ADDENDUM NO. 2

Issued by: Sacramento City Unified School District

Project: 0144-401, Hubert H. Bancroft Playground

2021 PAVING REPAIRS

C0.0

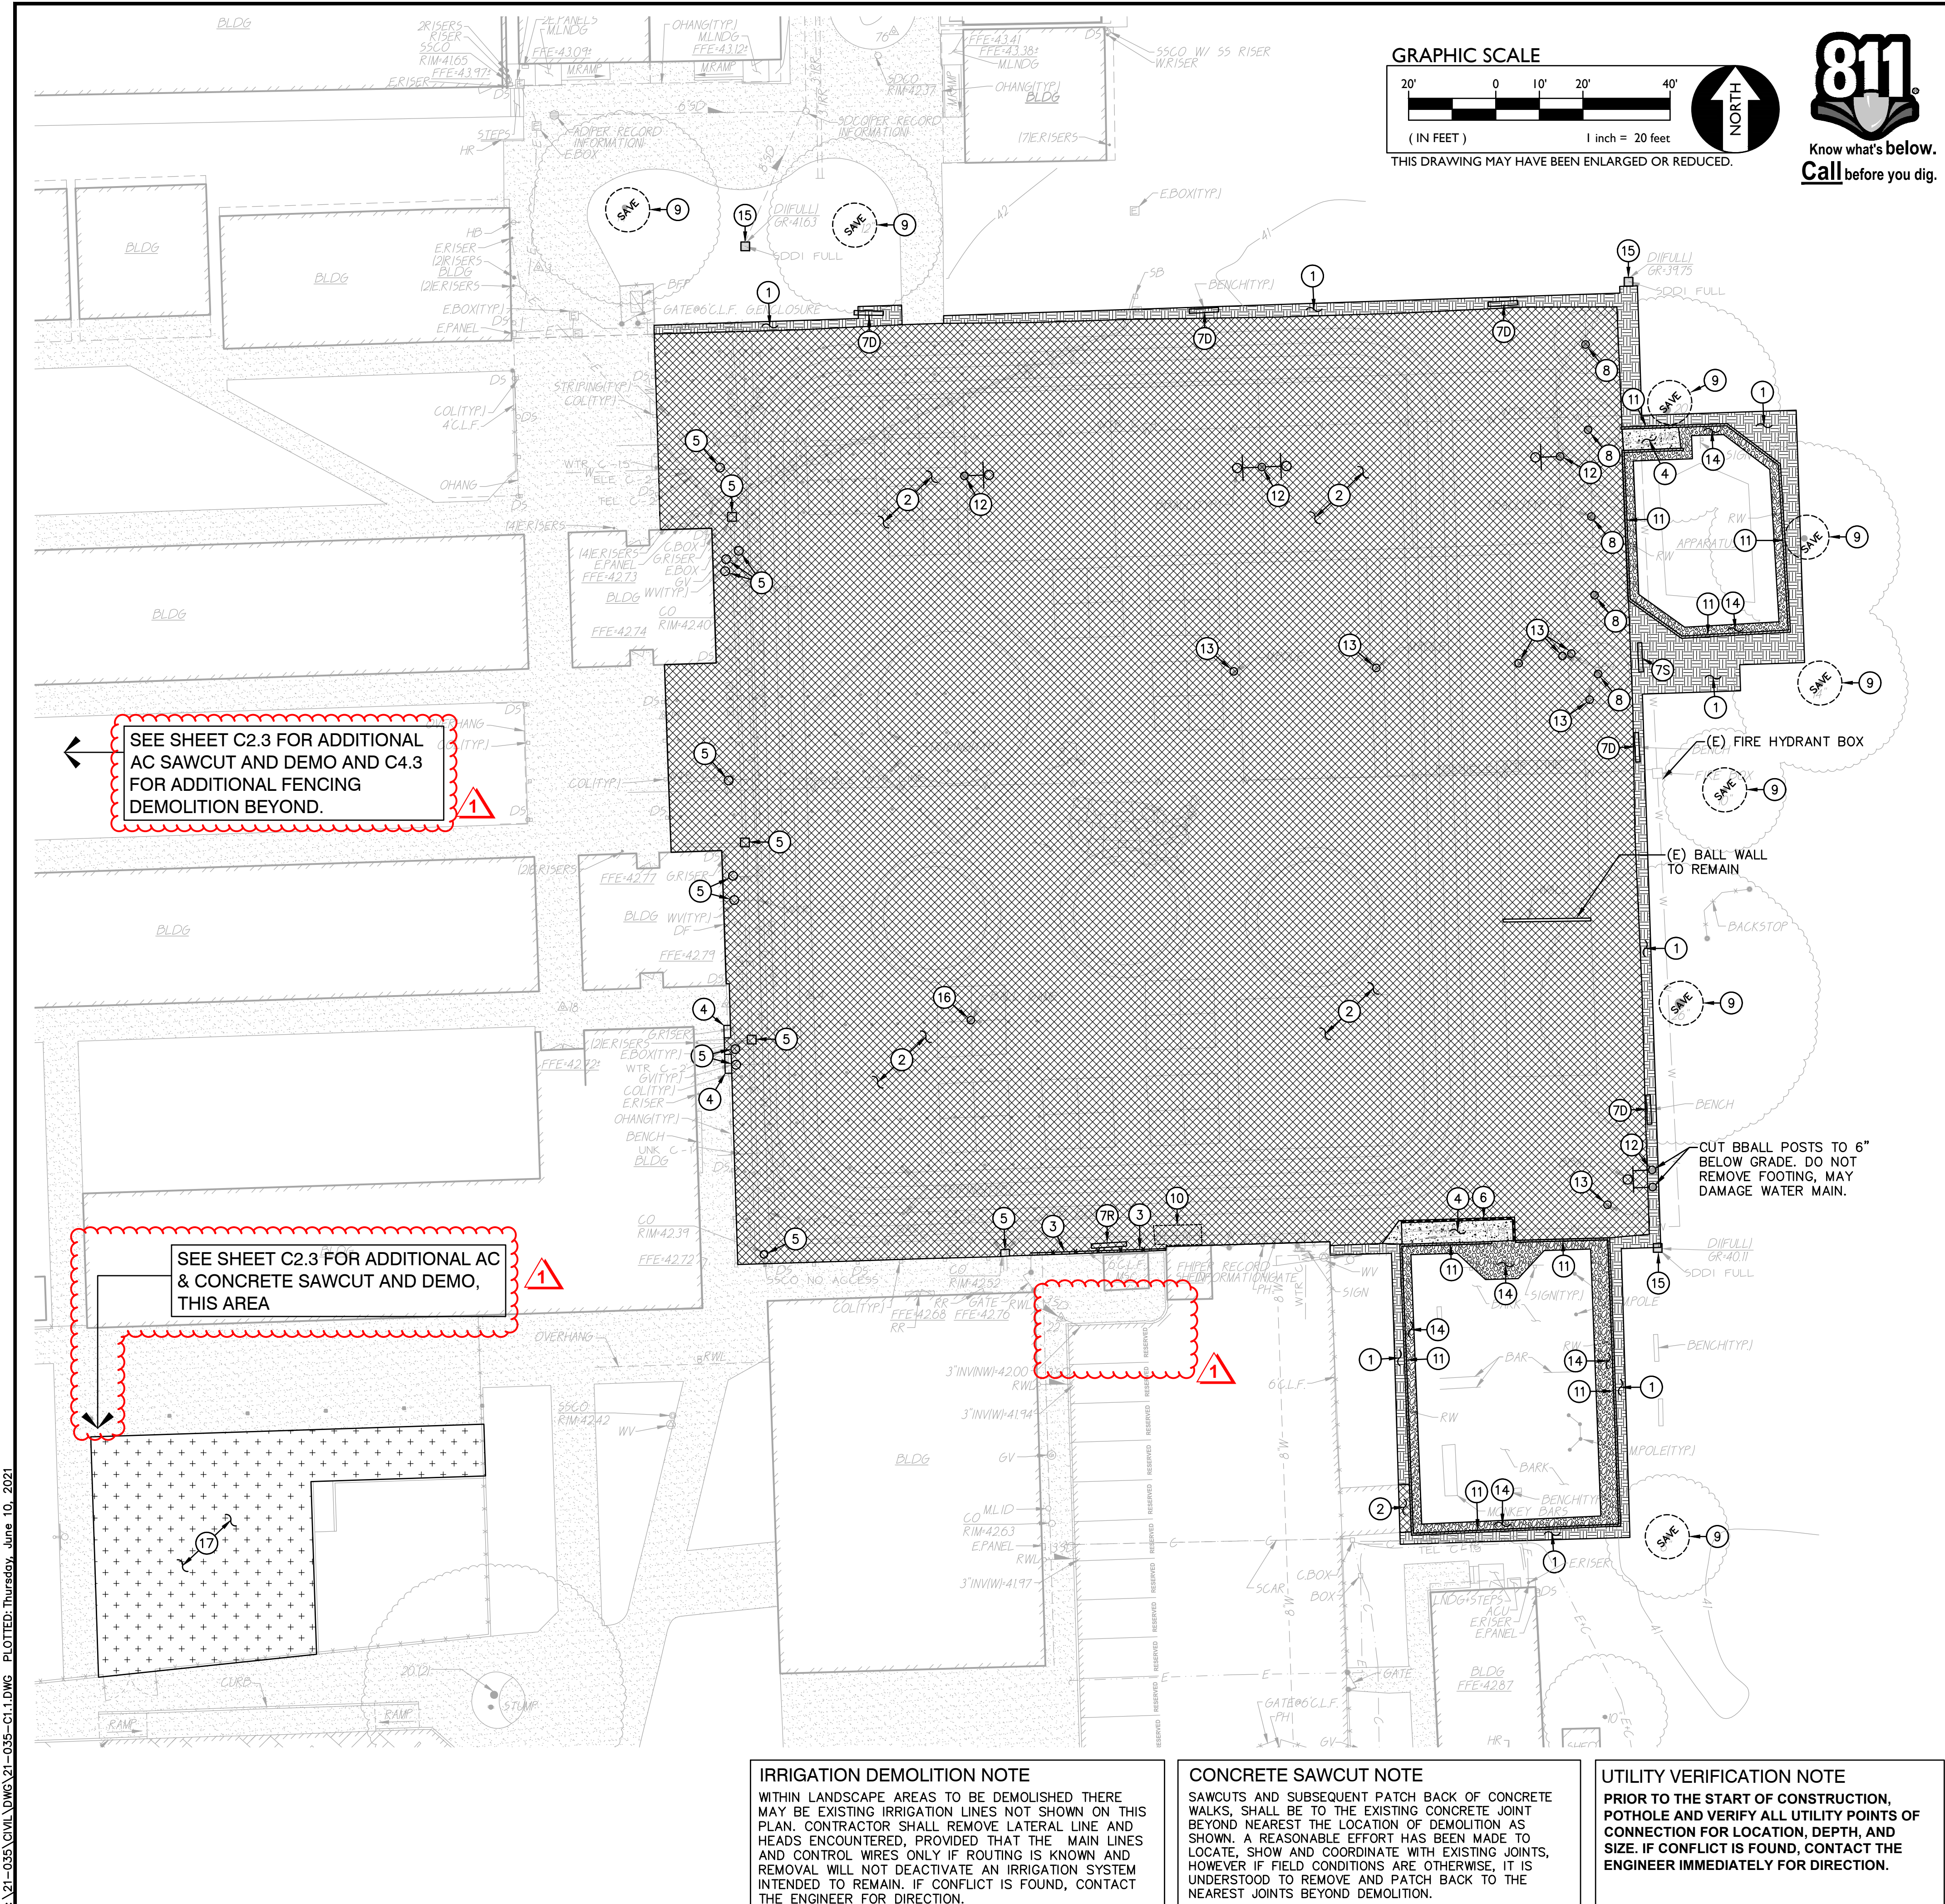
C0.0 – Cover Sheet

1. Sheet index has been updated to reflect new sheet C2.3

C1.1

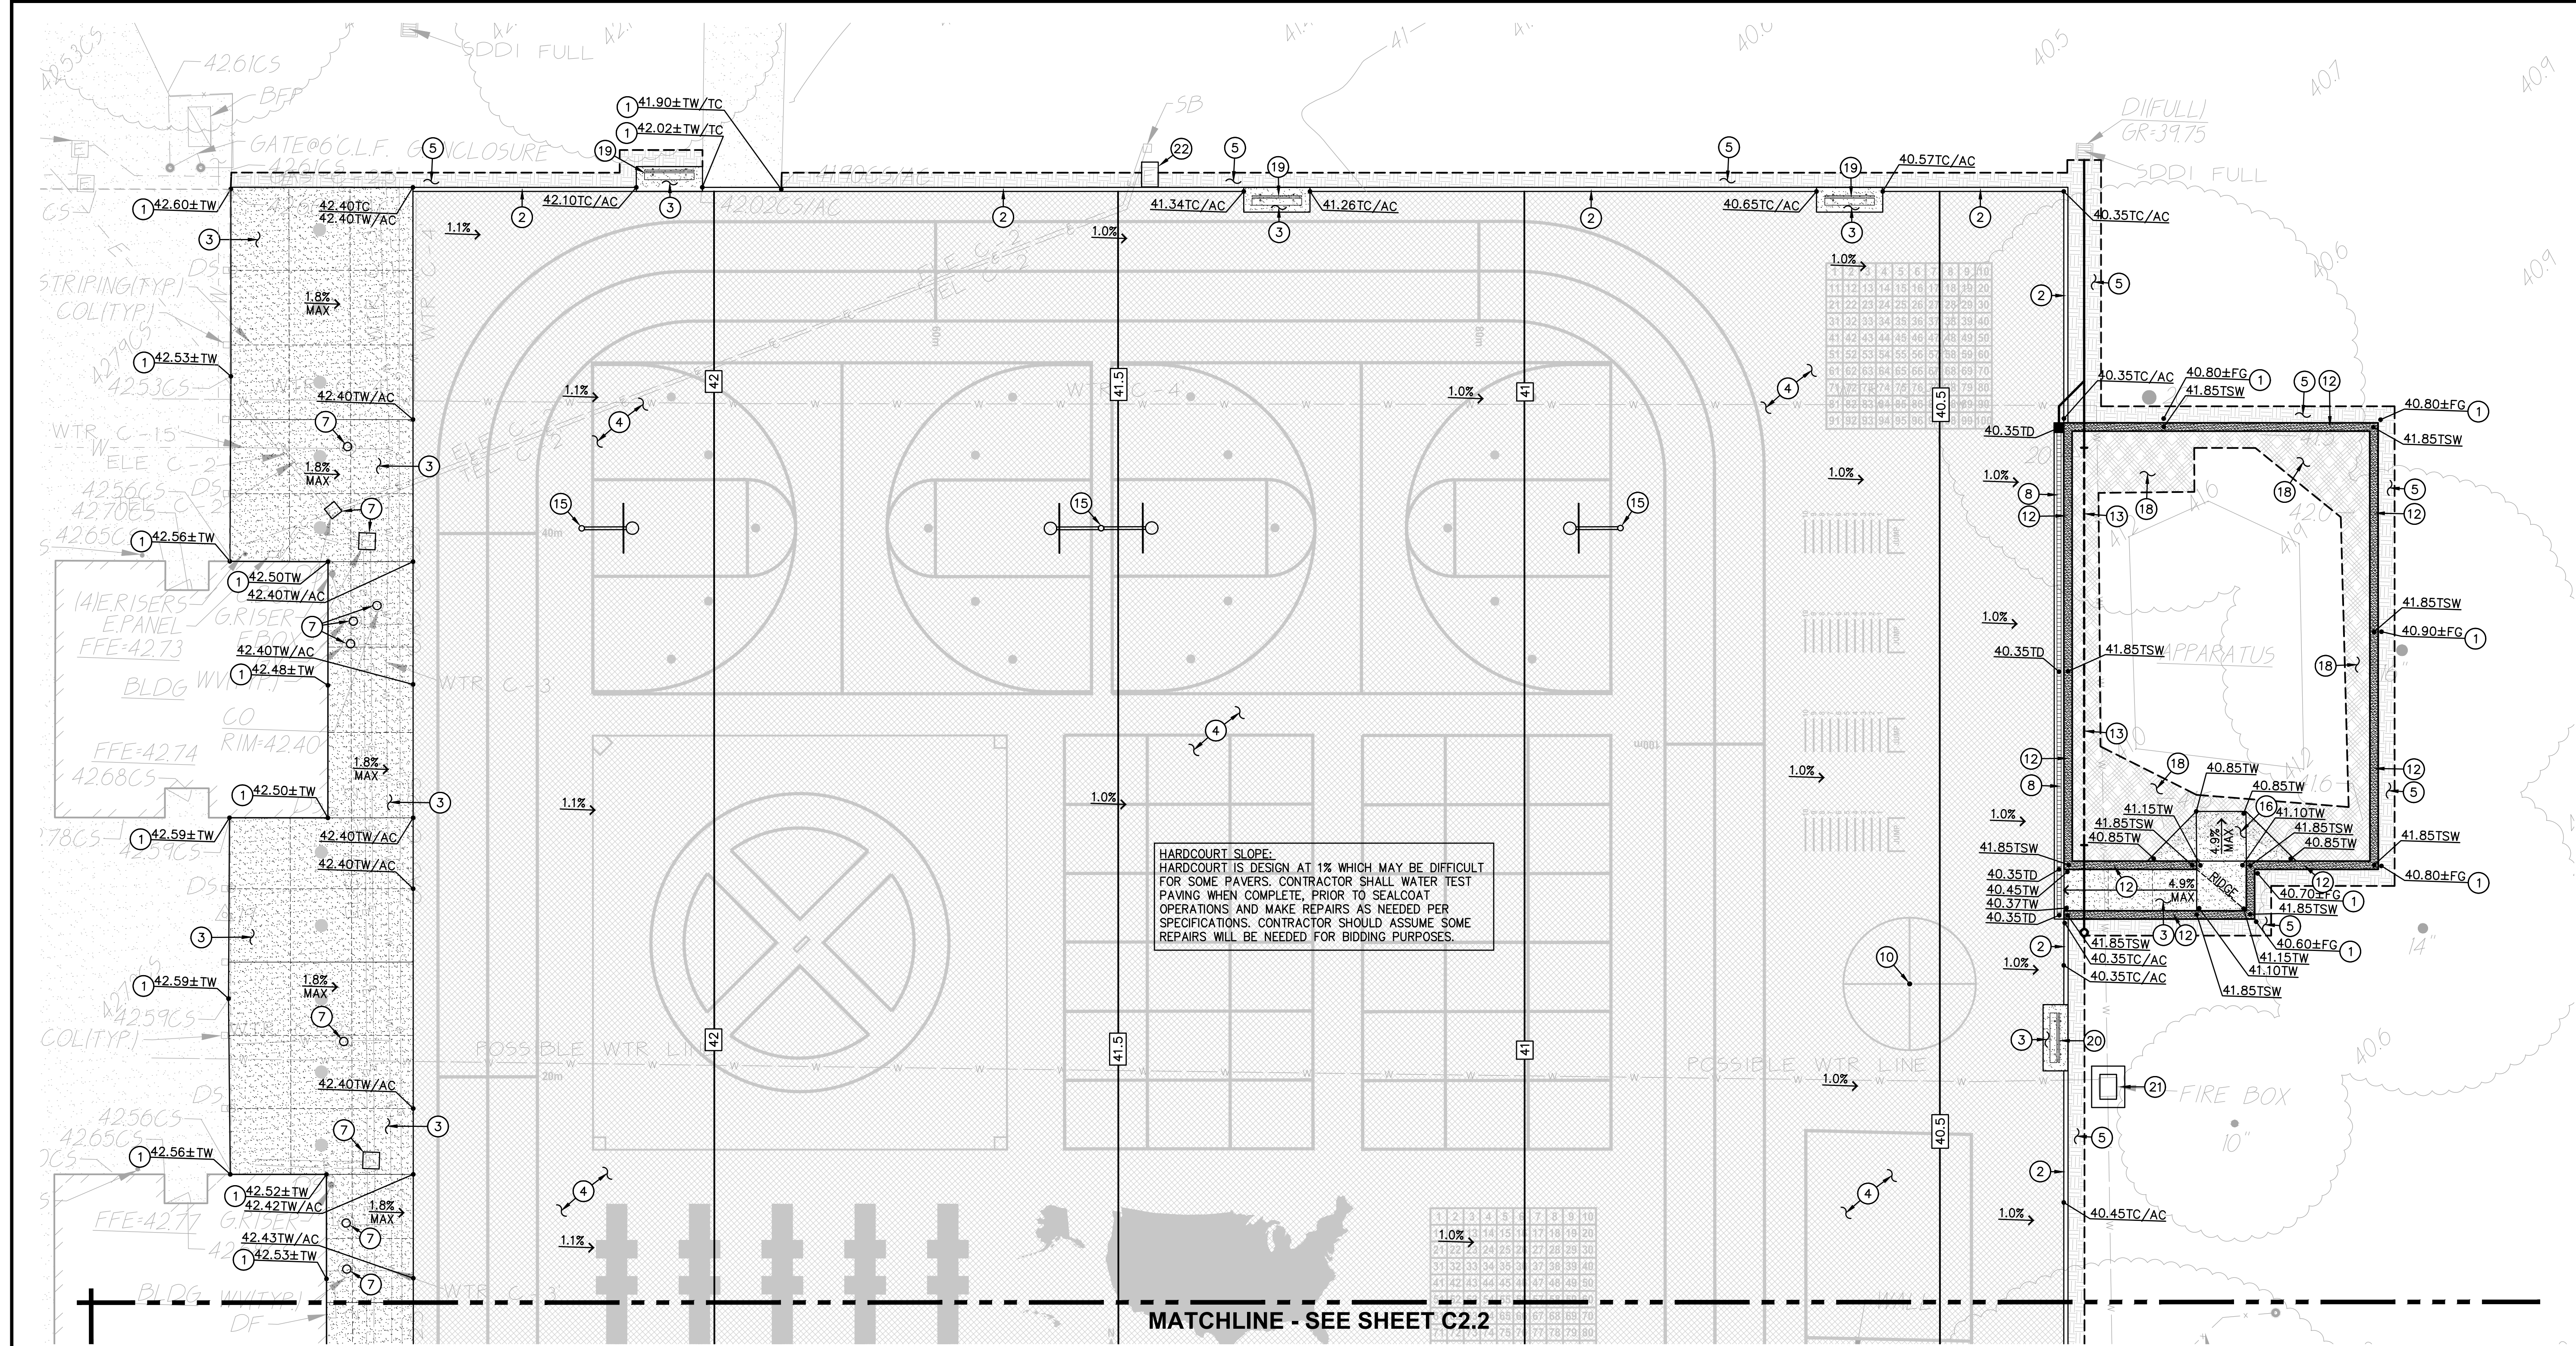
C1.1 – Demolition Plan

1. View 1 has been updated to reflect additional demolition shown on other sheets and reference those sheets for reference.
2. Demolition for 1 parking stall south of the large hardcourt has been eliminated. The parking stall work in that area was eliminated on all other sheets but the demolition work still remained by error.

SEE SHEET C2.3 FOR ADDITIONAL AC SAWCUT AND DEMO AND C4.3 FOR ADDITIONAL FENCING DEMOLITION BEYOND.

SEE SHEET C2.3 FOR ADDITIONAL AC & CONCRETE SAWCUT AND DEMO, THIS AREA

SHEET NO.
C2.1

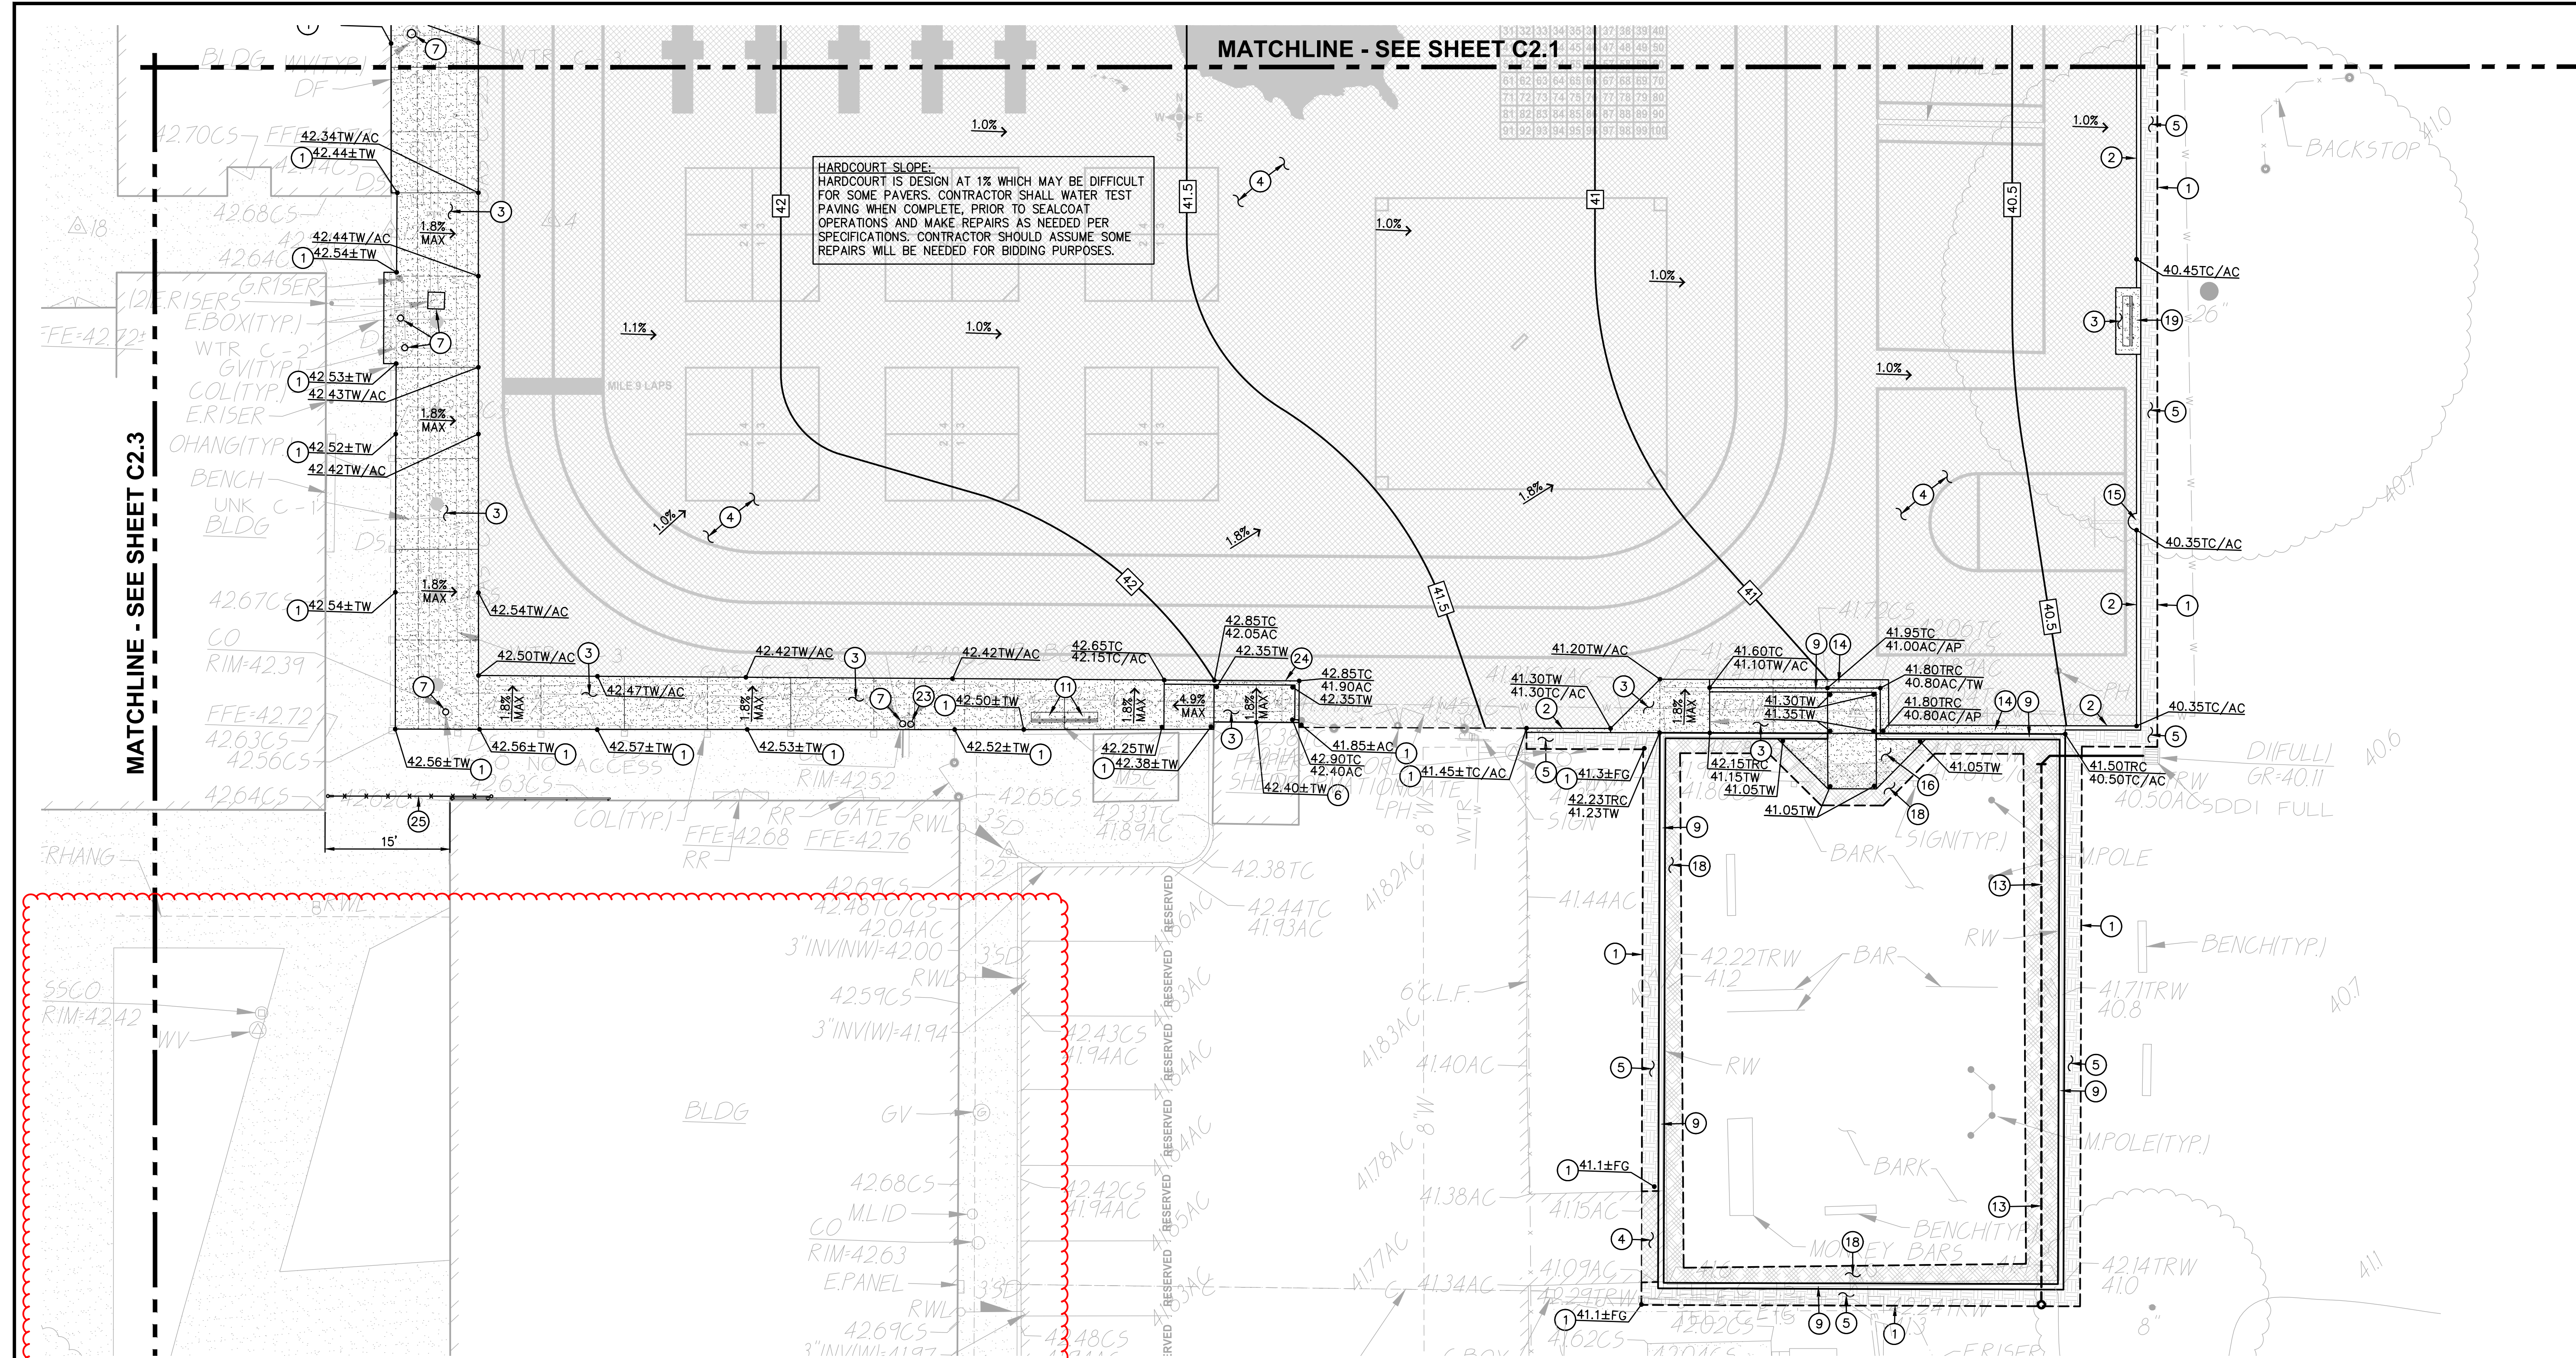
As noted in construction note 4, and which applies to the paving on C2.1 and C2.2, sealcoat is not required for the large hardcourt area. It was understood that there was no time for the 30 day cure on this new AC so it was eliminated for the new AC in this area. It will be provided at a later date under separate contract.

C2.1 – Grading Plan

1. Per bid comment, construction note 17 has been eliminated from the plan. The work related to this note was previously removed from the scope and this note is no longer needed.

4. PLACE 3" TYPE B (3/8" MAX) ASPHALT PAVING OVER 5" COMPACTED CLASS II AB OVER SUBGRADE PREPARED IN ACCORDANCE WITH SHEET C2.0. REFER TO SPECIFICATIONS SECTION 32 12 00 FOR MATERIALS AND CONSTRUCTION. REFER TO SECTION 31 00 00 AND 31 32 00 FOR SUBGRADE PREPARATION. SEALCOAT IS NOT REQUIRED ON THIS AREA.
